TO: Madeleine Reinke, Kimley-Horn and Associates, Inc.
FROM: Cynthia Thye, Planner 1
DATE: December 31, 2025
SUBJECT: SP25-119: Lincoln Professional Park L2 - 7 Brews Coffee – Site Plan
Review Comments 02

LINCOLN PROFESSIONAL PARK FILING NO. 1
LOT 2, PARKER, CO
7 BREW - SITE PLAN
COVERSHEET

LINCOLN PROFESSIONAL PARK FILING NO. 1
LOT 2, PARKER, CO
7 BREW - SITE PLAN
SITE PLAN

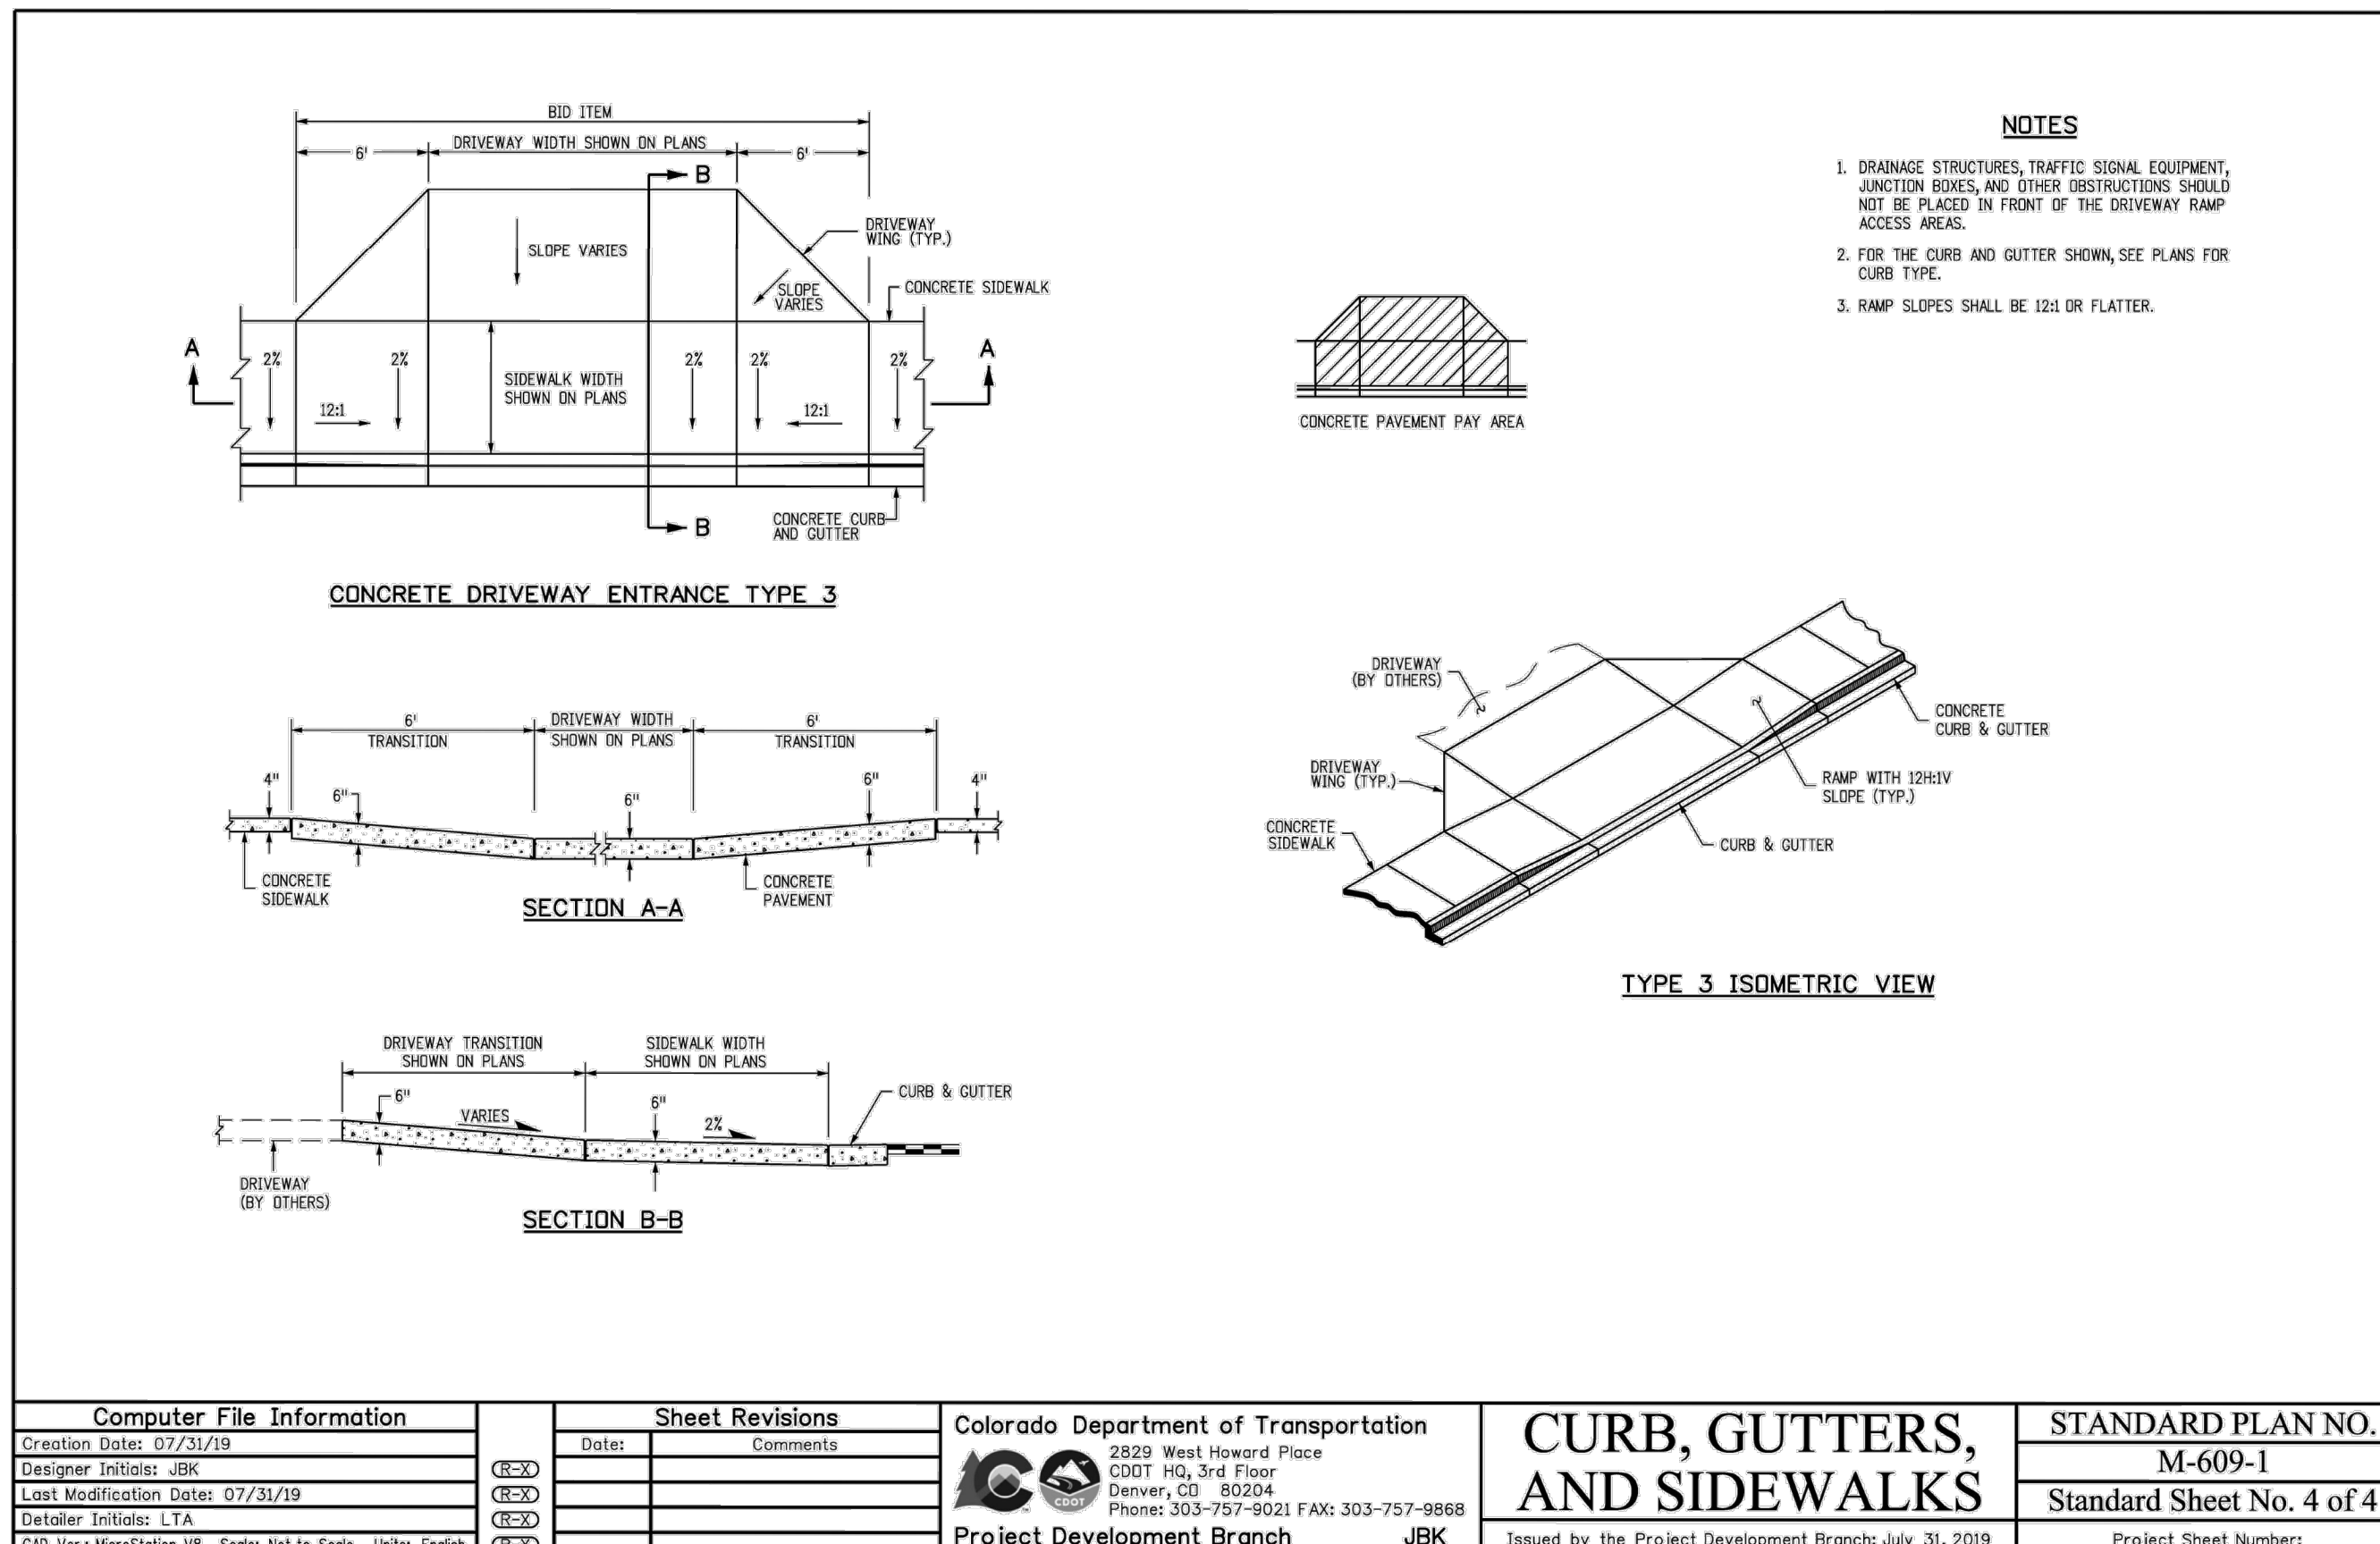
3. **Per LDO Administrative Manual, indicate feet from building to property lines on all four sides. This will also be needed for FLC inspection. Also, add length from building to driveway to ensure DDS compliance.**

Understood, a dimension showing the distance from the building to the property line on all four sides has been added.
